SUBJECT: Approval of the request of Hadley's Towing, JSP 16-33, with Zoning Map Amendment 18.715, to rezone property in Section 17, located on the south side of Grand River Avenue between Wixom Road and Beck Road from I-1, (Light Industrial) to I-2 (General Industrial), subject to the related Planned Rezoning Overlay (PRO) Agreement, and corresponding PRO Concept Plan. The property totals 17.78 acres and the applicant is proposing to rezone approximately 5.6 acres of the northerly portion of the property to accommodate a vehicle towing business and outdoor storage yard.

PLANNING REVIEW

Review Date: November 23, 2016
Review Type: PRO Concept Plan
Project Name: JSP 16-33 Hadley's Towing
Plan Date: August 11, 2016
Prepared by: Sri Komaragiri, Planner
E-mail: skomaragiri@cityofnovi.org; **Phone:** (248) 735-5607

Figure 1. City of Novi Regulated Wetland & Woodland Map (approximate project area is highlighted in red). Regulated Woodland areas are shown in green and regulated Wetland areas are shown in blue).

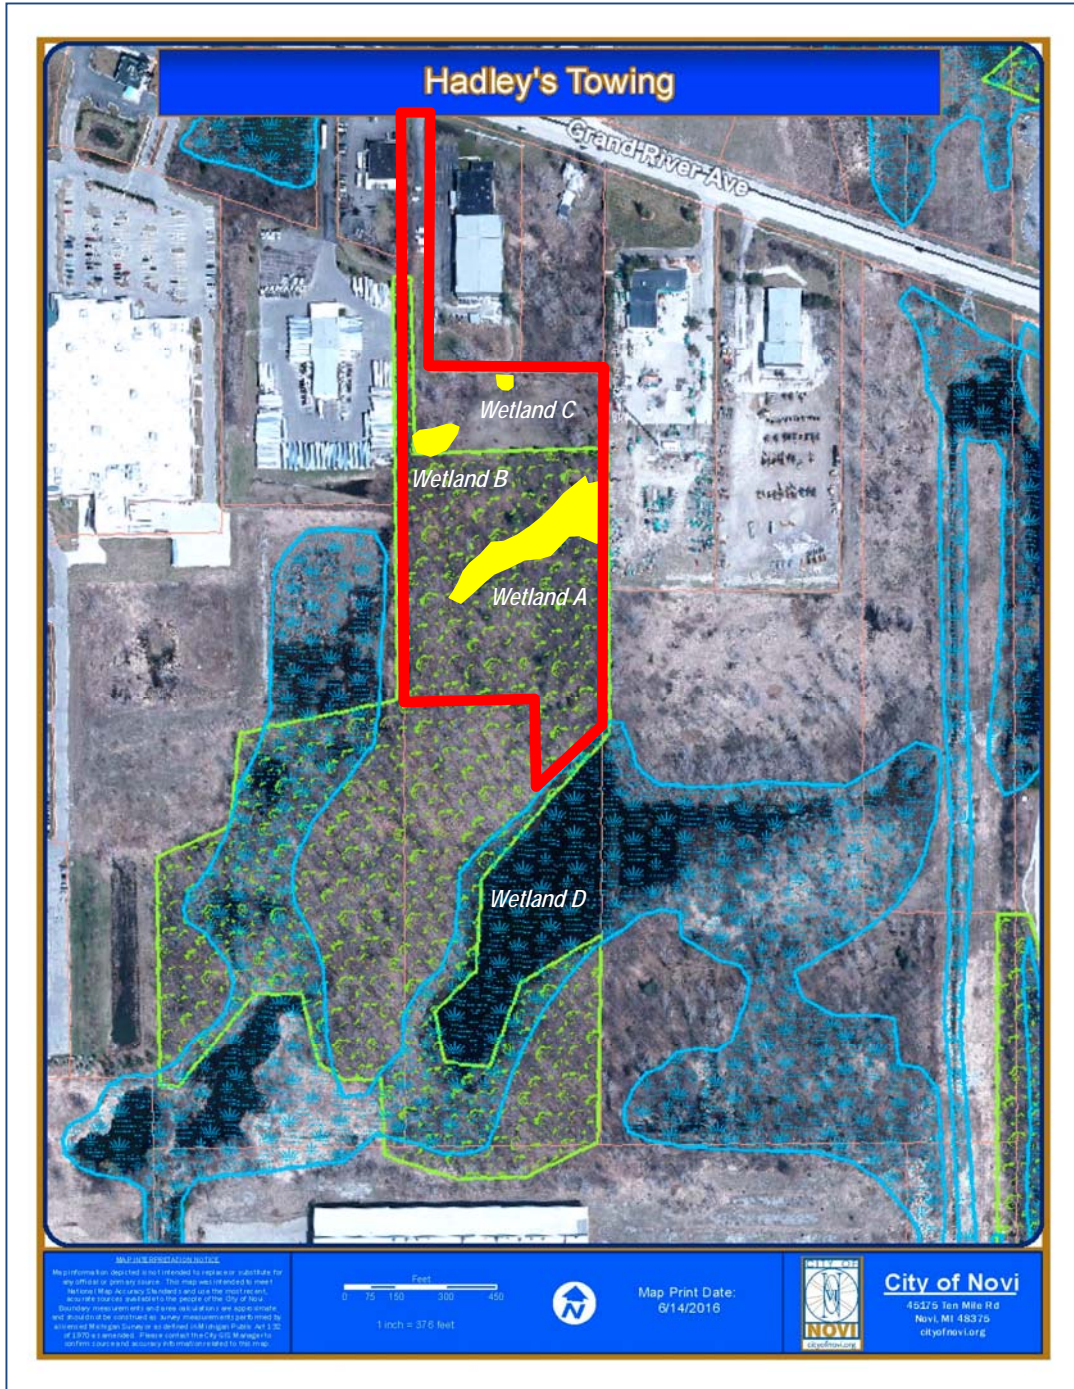
Based on our review of the Plan, Novi aerial photos, Novi GIS, the City of Novi Official Wetlands and Woodlands Maps (see Figure 1, attached) it appears as if this proposed project site contains City-regulated wetlands and woodlands. The City's wetland and woodland map shows that the overall property contains wetlands to the south. However, a review of aerial photos of the site, the proposed site plan, and previous site visits, the site contains four (4) total areas of wetland (Wetlands A, B, C, and D).

Figure 1. City of Novi Regulated Wetland & Woodland Map (approximate project area is highlighted in red). Regulated Woodland areas are shown in green and regulated Wetland areas are shown in blue).

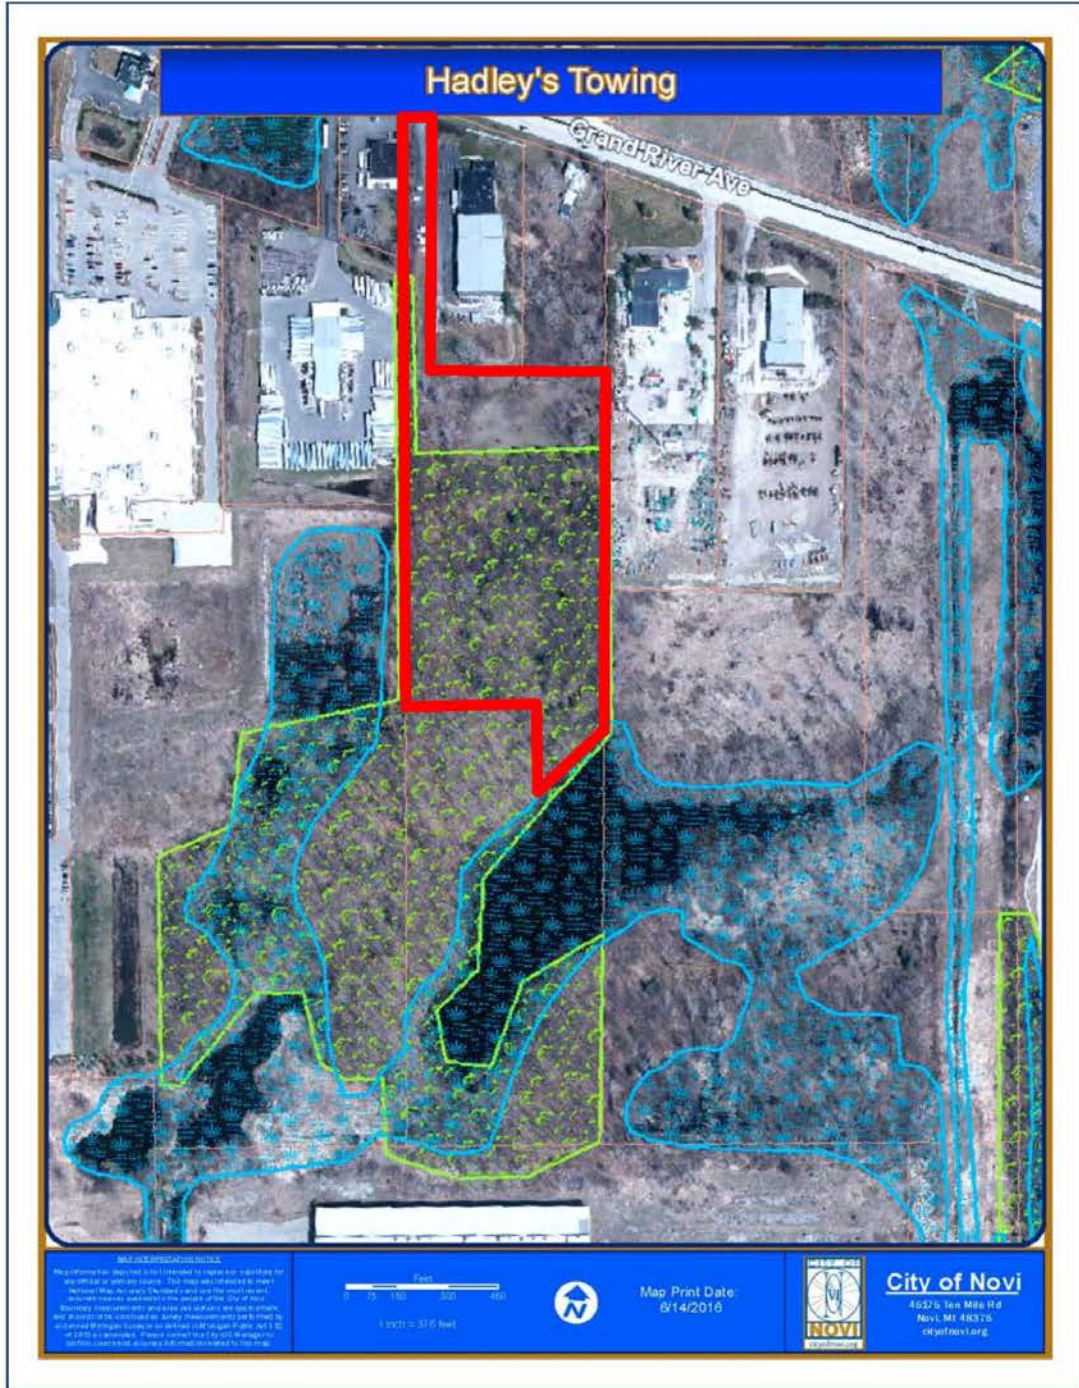
The site does contain areas noted as City of Novi Regulated Woodlands. The majority of the property contains Regulated Woodland (see Figure 1). The current plan includes a partial tree list and a partial list of the proposed tree removals. The plan notes that "*tree locations on south portion of site not available at time of concept plan submittal*". As such, the total impact to existing trees associated with the proposed detention basin and associated stormwater outfall pipe are not calculated on the Plan. The previously submitted concept plan stated that "*tree survey to be performed on south portion of property at the time of preliminary site plan submittal*".
